ADDENDUM #1

Stillaguamish Tribal Court

August 10, 2020

Drawing A2.1:

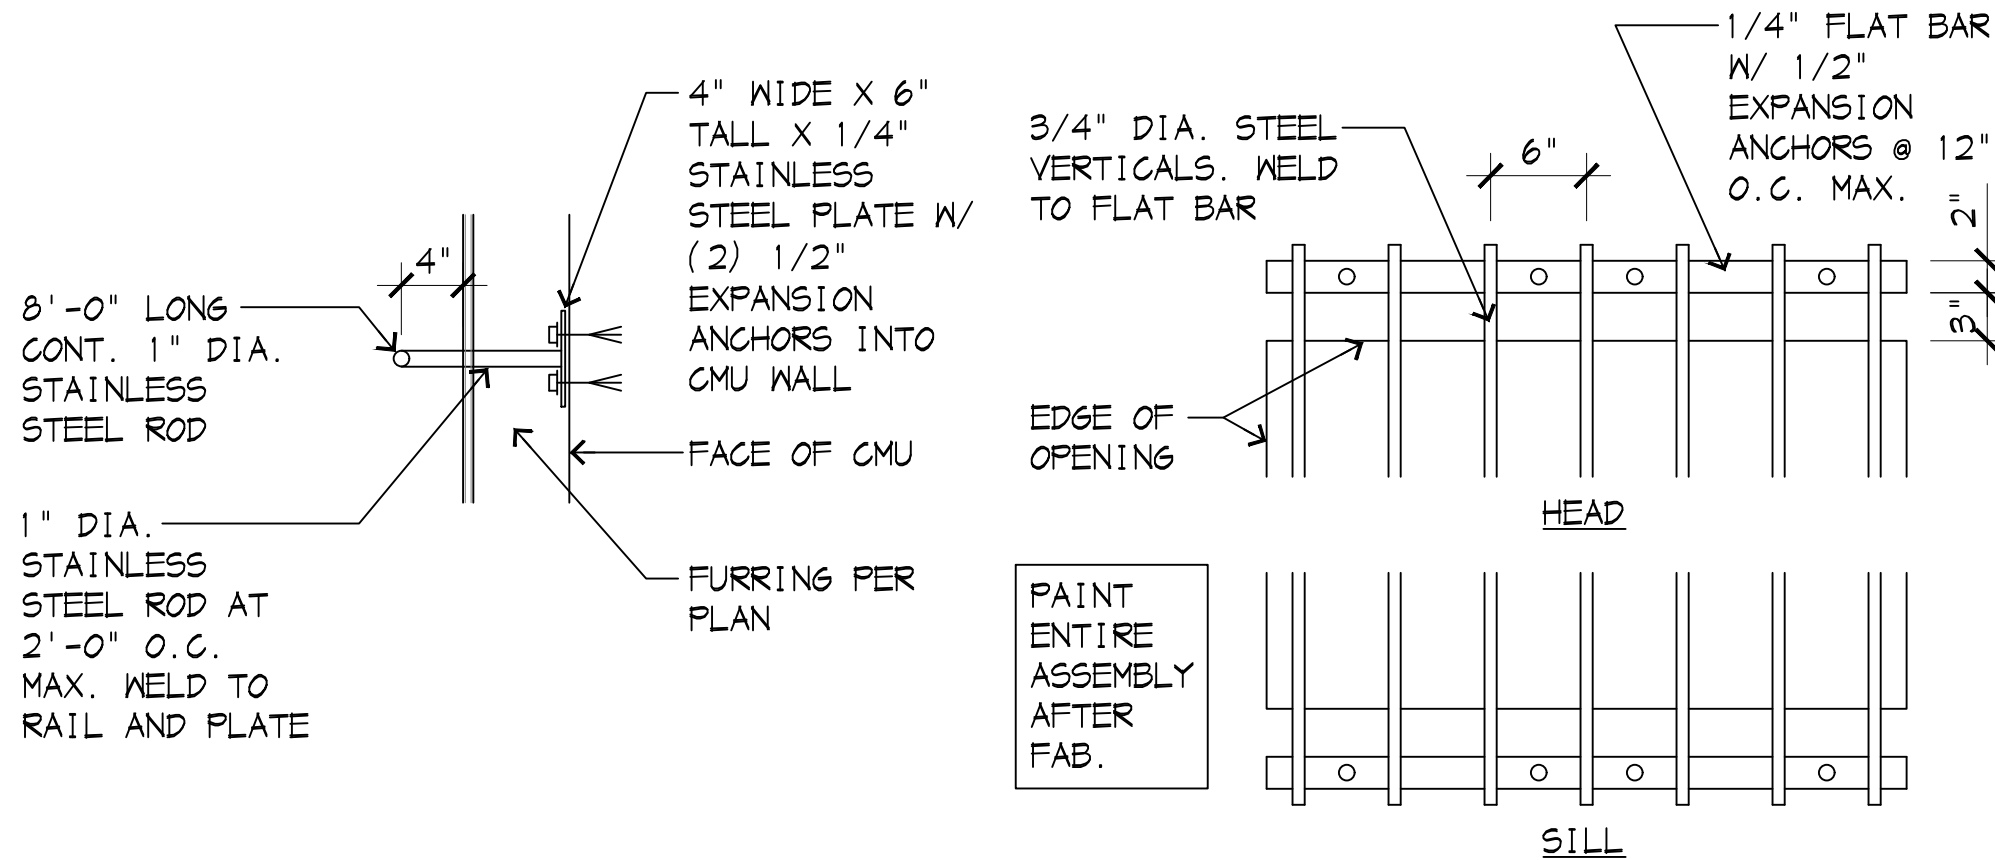
- The metal detector will be supplied by the building owner and installed by the general contractor. Wood stud framing will need to be installed adjacent to the metal detector a minimum distance of 6'-0" each side of the unit in order to reduce the possibility of false alarms.
- Handcuff rail and security bars are intended to be constructed as shown on details 17 and 18 on drawing A5.2.
